· ATTACHMENT 1

Updates  
In This Submittal

DIABLO CANYON POWER PLANT  
PROCEDURE ON-THE-SPOT CHANGEProcedure No. EP 6-2 Rev. 2.3 Unit No. 1 ☐ 2 ☐ 1 & 2 ☒Title Establishment of the Onsite Emergency OrganizationType of Change: ☐ PERMANENT (green) ☒ TEMPORARY (yellow); Expiration Date 1/31/83Requesting Department Technical Originator LFWomackProposed Change: (Does this alter the intent of original procedure? ☐ Yes ☒ No)(Does it constitute an unreviewed safety/environmental question? ☐ YES ☒ NO)

Nuclear Plant Operations  
69-10709 (4/82)DIABLO CANYON POWER PLANT  
PROCEDURE ON-THE-SPOT CHANGEProcedure No. EP-EF-S Rev. 1 Unit No. 1 ☐ 2 ☐ 1 & 2 ☒Title Emergency Equipment, Instruments and SuppliesType of Change: ☒ PERMANENT (green) ☐ TEMPORARY (yellow); Expiration Date \_\_\_\_\_Requesting Department Chem & Rad Protection Originator H FongProposed Change: (Does this alter the intent of original procedure? ☐ Yes ☒ No)(Does it constitute an unreviewed safety/environmental question? ☐ YES ☒ NO)

FIGURE 1 GARAGE LAYOUT AND PHONE ACCESS

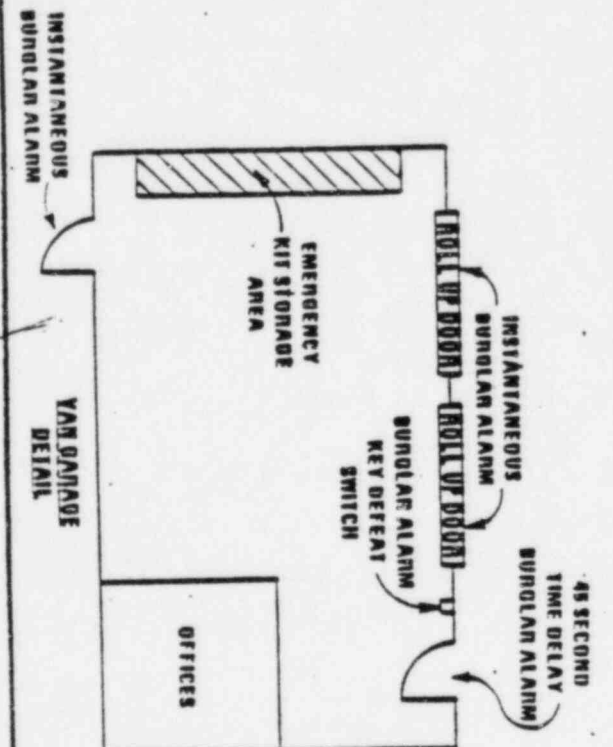
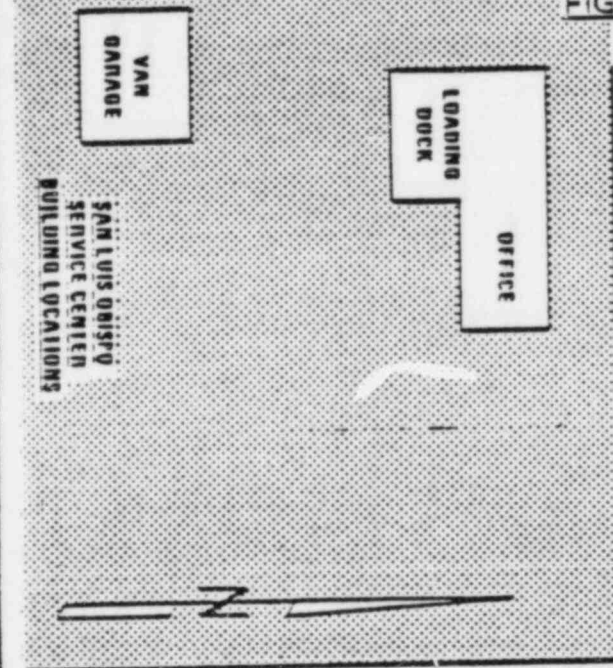
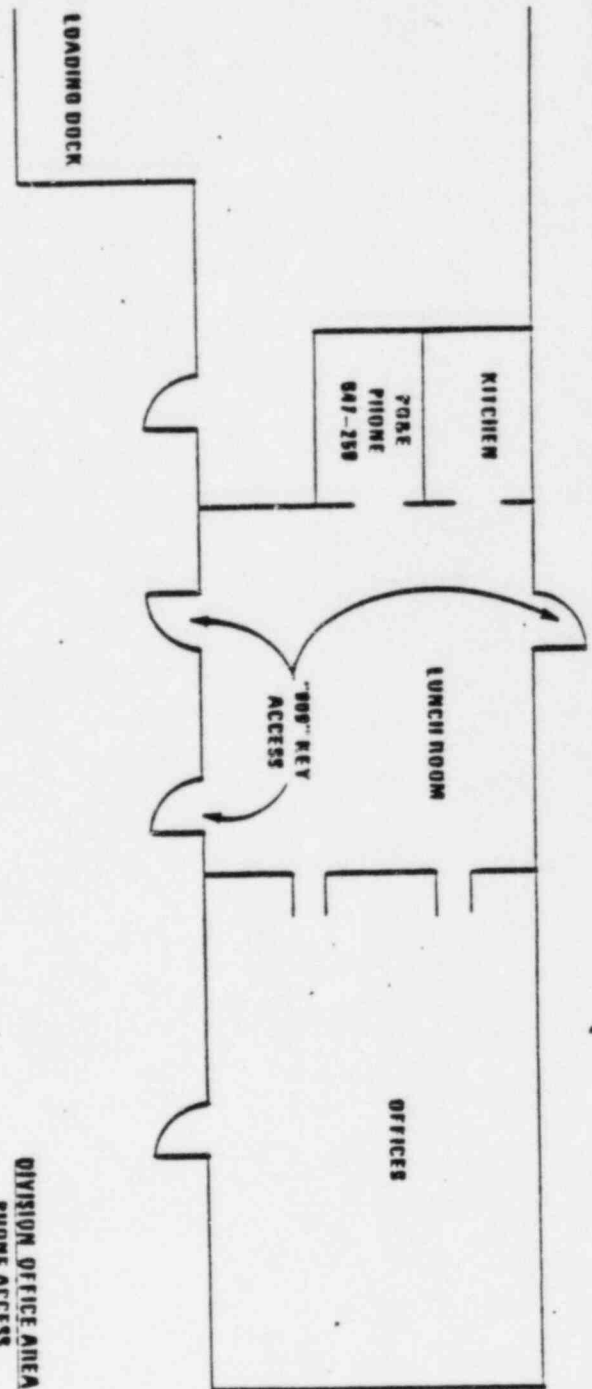
NOTE: If the MEML garage is locked, personnel should not open the door without a burglar alarm defeat key available. The front door is the only access that has a 45 second time delay to permit use of the defeat key (see Figure 1). The defeat key is available from the plant if the DER personnel are not available. The DER personnel will be called out as part of the call-out list in Emergency Procedure EP G-2.

- a. When PG&E personnel have reached the MEML garage, establish telephone contact with the Radiological Emergency (RERM) at the Emergency Operations Facility (EOF) (see Attachment 1). If the MEML garage is locked and access cannot be obtained from the DER personnel assigned to the van, then use the telephone in the division office building (see Figure 1).

- A. After section labelled "ATTACHMENTS", include the following heading: FIGURE
1. San Luis Obispo Service Center Garage layout
- B. Include Figure 1, attachment.
- C. Delete existing Table 2 "Contents of Radiological Emergency Kits" and replace with revised table enclosed here.
- D. Delete existing Table 4 "Contents of Hospital Kits" and replace with revised table enclosed here.
- E. Replace Form 69-9823-2 Rev 4/82 with Form 69-9823-2 Rev 9/82 enclosed here.
- F. Replace Form 69-9823-3 Rev 4/82 with Form 69-9823-3 Rev 9/82 enclosed here.
- G. Include Form 69-10598 Rev 11/82.
- H. On section labelled "ATTACHMENTS", include the following:
13. 69-10598 Hospital Kit Inventory Checklist

Figure 2B. Response Curve for RE-33

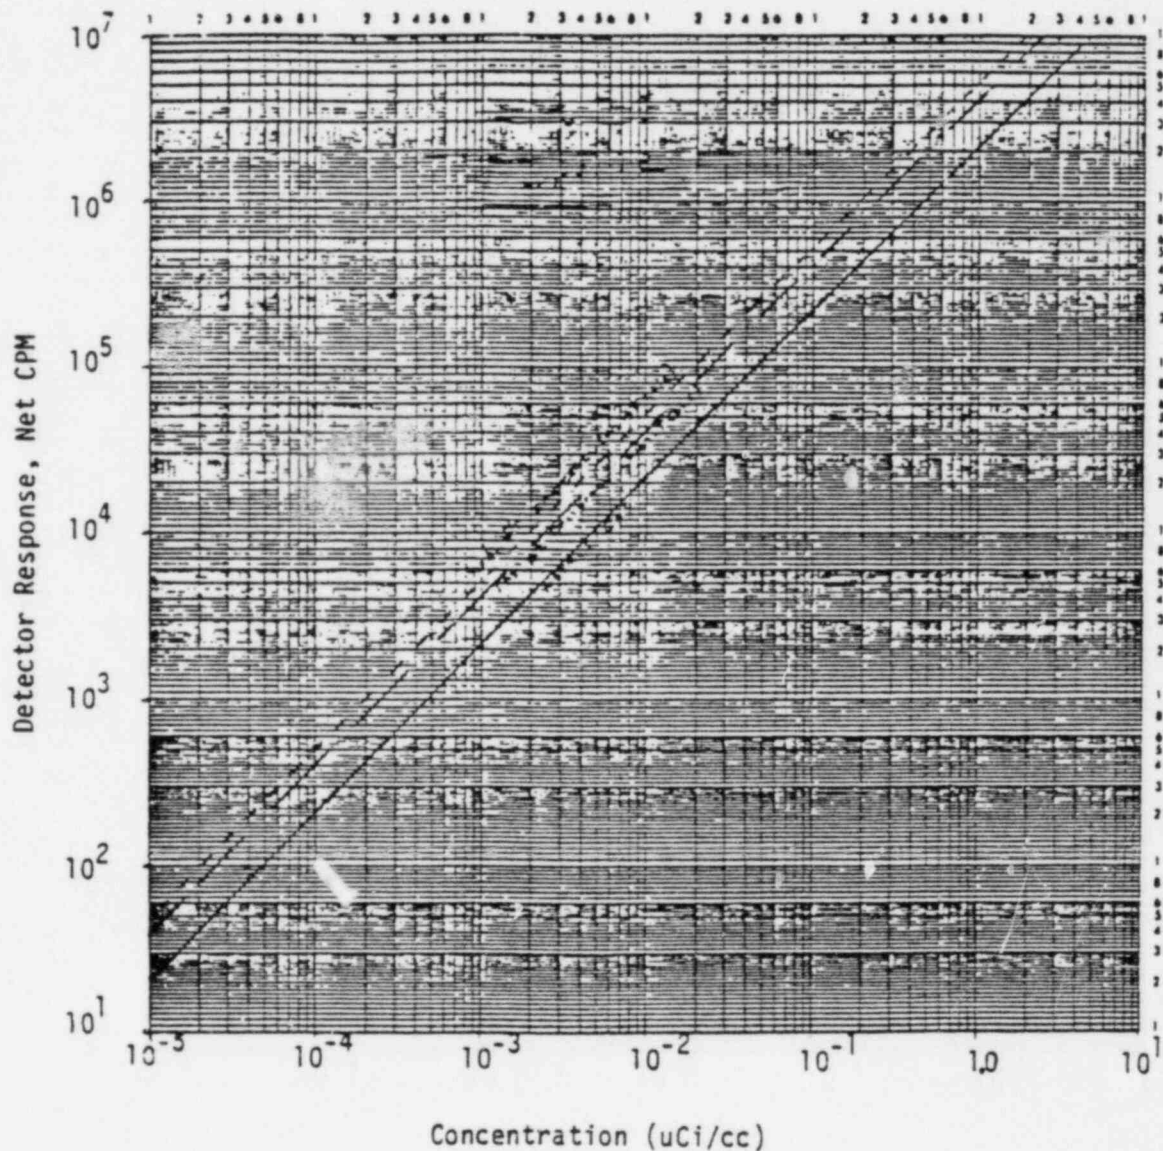
1. Figure 2B--"Response Curve for RE-33" replaces the equation:

1. The plant staff has reviewed the equation for calculating plant vent noble gas concentration for RE-33 currently in RB-12. It has been found to be in error. In addition, a detailed calibration has been undertaken to determine the counting efficiency of RE-33. The curve provided in Figure 2B is based on this new analysis of RE-33's response.

Exposure Rate/Effluent Concentration Response Curve for RE 29  
10 Cycle Log-Log

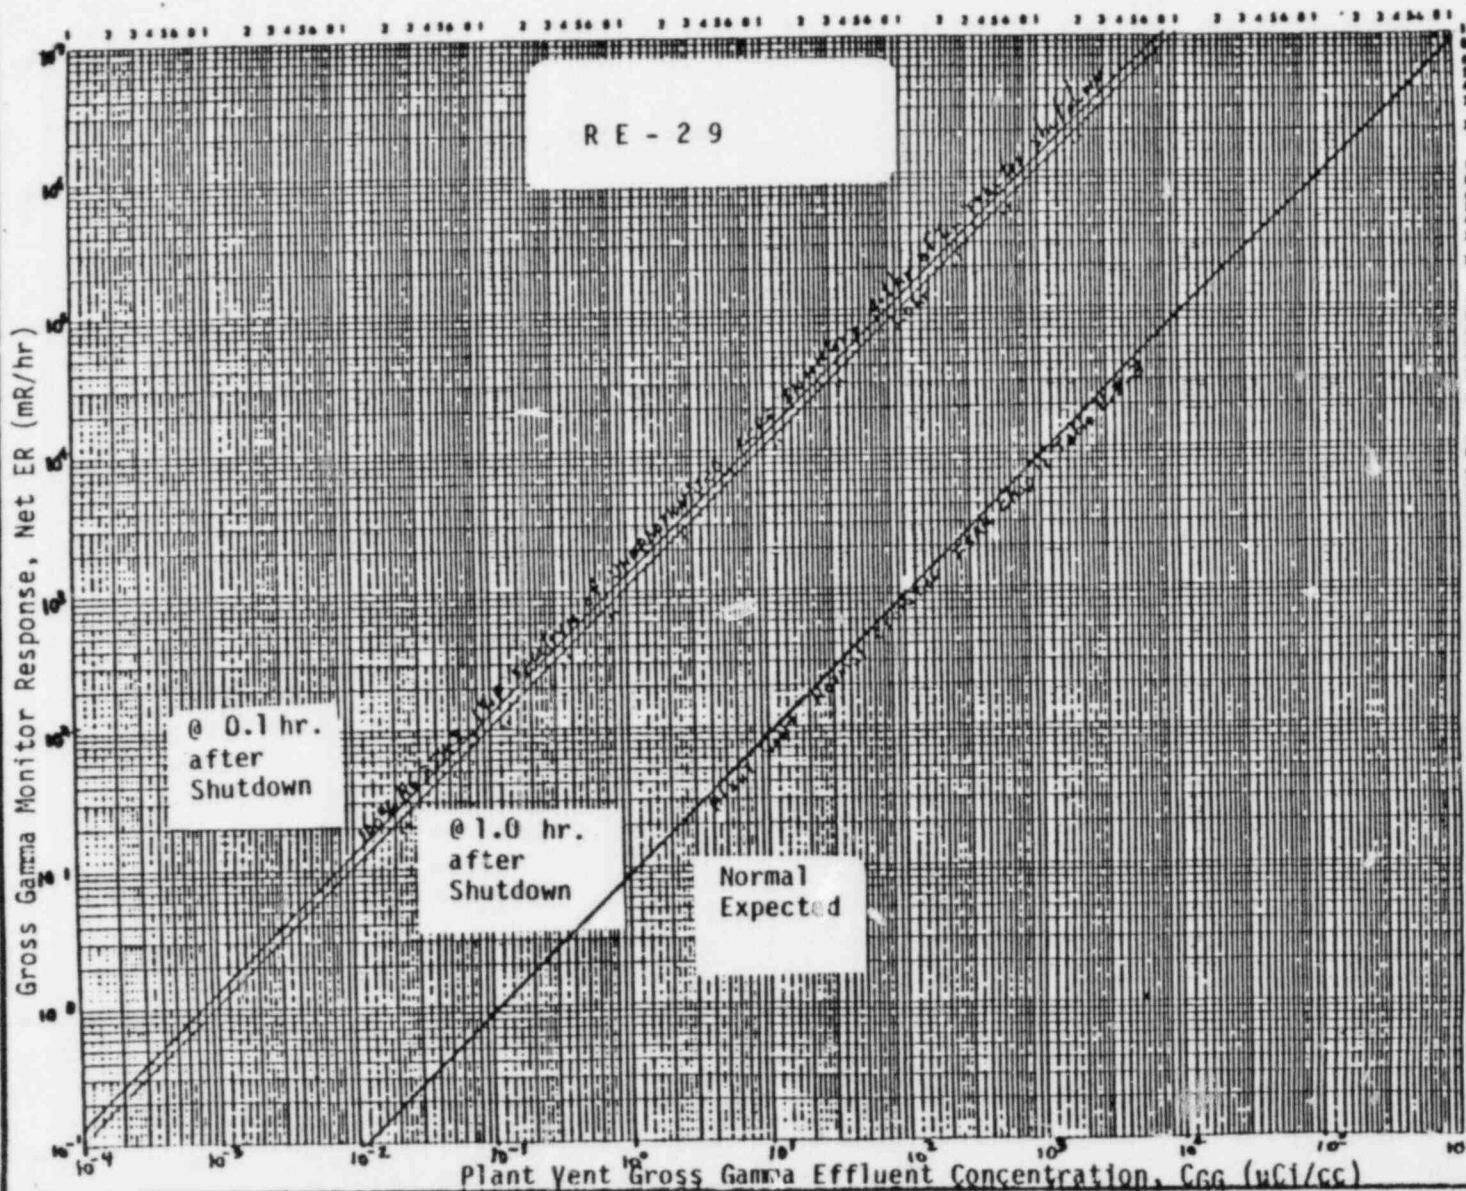
2. New response data for RE-29 is available based on updated calculations by the DCPD plant staff. The new figure provided in this change allows the new data to be utilized.
